Access Compliance Report

Public Rights-of-Way

(Curb Ramps)

Intersection ID: 48943	Main Street: CALDWELL RIDGE PY	Cross Street: MORGAN LEE AV	Location: SW
ADA ID: 6603D1536609	Ramp Type: BlendTrans1	Initial Pass/Fail: Fail	Overall Compliance: No
		Severity Score: 8.75

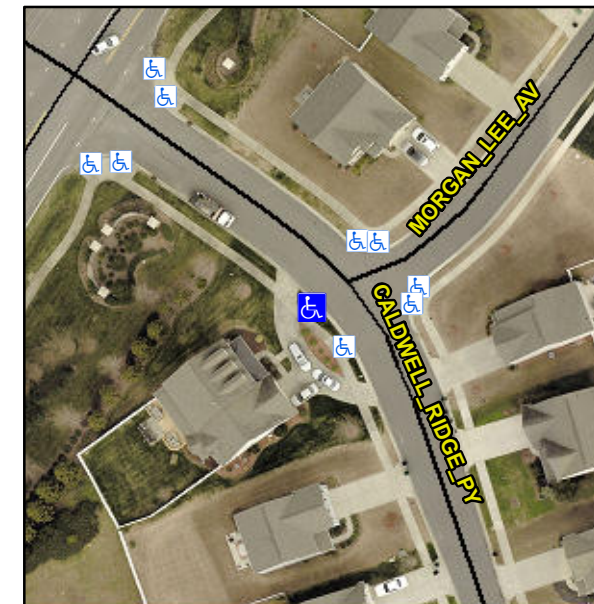
Not Found, R304.5.1

Compliance	Description	Data	Compliance	Description	Data
N/A	Ramp Length (in)	72.0	Yes	BlendTrans Slope (%)	4.5
No	Ramp Width (in)	47.0	Yes	BlendTrans XSlope (%)	1.2
N/A	Flare Type LT	N/A	N/A	Flare Type RT	N/A
N/A	Flare Slope LT (%)	N/A	N/A	Flare Slope RT (%)	N/A
N/A	Flare Traversable LT?	N/A	N/A	Flare Traversable RT?	N/A
N/A	Landing Length (in)	N/A	N/A	DWS Provided?	N/A
N/A	Landing Width (in)	N/A	N/A	DWS Contrast?	N/A
N/A	Landing Slope (%)	N/A	N/A	DWS Length (in)	N/A
N/A	Landing X Slope (%)	N/A	N/A	DWS Full Width?	N/A
N/A	Landing Curb? (Y/N)	N/A	N/A	DWS Offset (in)	N/A
N/A	Shared Landing?	N/A			
N/A	Gutter Ponding?	N/A	N/A	Gutter Slope (%)	N/A
N/A	Gutter Lip Ht (in)	N/A	N/A	Gutter X Slope (%)	N/A
N/A	Painted X Walk1?	No	N/A	Painted X Walk2?	N/A
	X Walk 1 Direction	To NE		X Walk 2 Direction	N/A
	X Walk 1 Width (in)	N/A		X Walk 2 Width (in)	N/A
	X Walk 1 Slope (%)	3.3		X Walk 2 Slope (%)	N/A
	X Walk 1 X Slope (%)	0.7		X Walk 2 X Slope (%)	N/A

N/A	Ramp inside XWalk1?	N/A	N/A	Ramp inside XWalk2?	N/A
	Road Slope (%)	0.7		Clear Space?	N/A
	Road X Slope (%)	3.3	N/A	Clear Space to XWalk (in)	N/A
N/A	Any Obstructions?	N/A	N/A	Storm Grate/Utility Hazard?	N/A
	Obstruction Type			Storm Grate/Utility Type	
		N/A			N/A
			Yes	Surface Condition? (G/P)	Good
			No	Curb Slope (%)	26.8

Remove & Replace Curb Ramp With Two New Directional Ramps or Equivalent.
